Access Compliance Report

Public Rights-of-Way

(Curb Ramps)

Intersection ID: 30009	Main Street: BACKWATER_DR	Cross Street: OLD_CAROLINA_DR	Location: W
ADA ID: D42670816E8A	Ramp Type: PerpDiag	Initial Pass/Fail: Fail	Overall Compliance: No
		Severity Score: 8.75

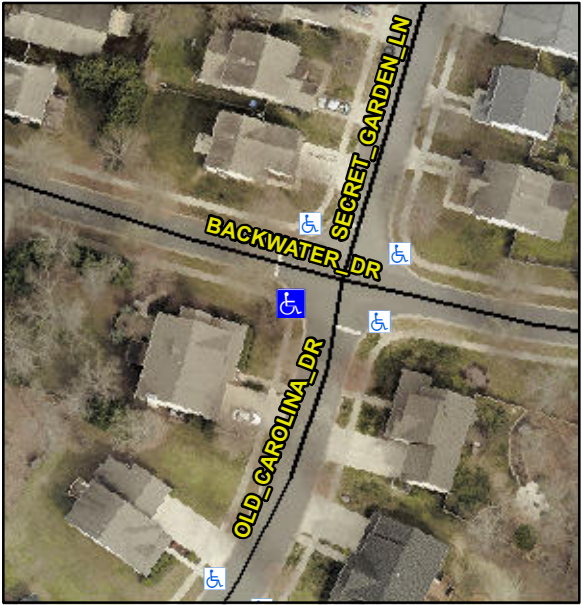
Codes/Mitigation Info/Possible Solution		Field Measurements/Component Compliance			
 Street 1 Name BACKWATER DR Stop Condition-Street 2 StopSign Street 2 Name OLD CAROLINA DR Stop Condition-Street 1 StopSign	Possible Solutions:	Remove & Replace Curb Ramp With Two New Directional Ramps or Equivalent.			
	Surveyor Notes:	N/A			
	PROW/ADA:	Not Found, R304.5.1			
	Total Cost:	\$ 3200.00			
			Compliance	Description	Data
			Yes	Ramp Length (in)	59.5
			No	Ramp Width (in)	45.0
			N/A	Flare Type LT	N/A
			N/A	Flare Slope LT (%)	N/A
			N/A	Flare Traversable LT?	N/A
			N/A	Landing Length (in)	N/A
			N/A	Landing Width (in)	N/A
			N/A	Landing Slope (%)	N/A
			N/A	Landing X Slope (%)	N/A
			N/A	Landing Curb? (Y/N)	N/A
			N/A	Shared Landing?	N/A
			N/A	Gutter Ponding?	N/A
			N/A	Gutter Lip Ht (in)	N/A
			N/A	Painted X Walk1?	No
			N/A	X Walk 1 Direction	To SE
			N/A	X Walk 1 Width (in)	N/A
			N/A	X Walk 1 Slope (%)	3.1
			N/A	X Walk 1 X Slope (%)	2.2

N/A	Ramp inside XWalk1?	N/A
			N/A	Road Slope (%)	0.4
			N/A	Road X Slope (%)	5.4
			N/A	Any Obstructions?	N/A
			N/A	Obstruction Type	N/A
			N/A	Surface Condition? (G/P)	Good
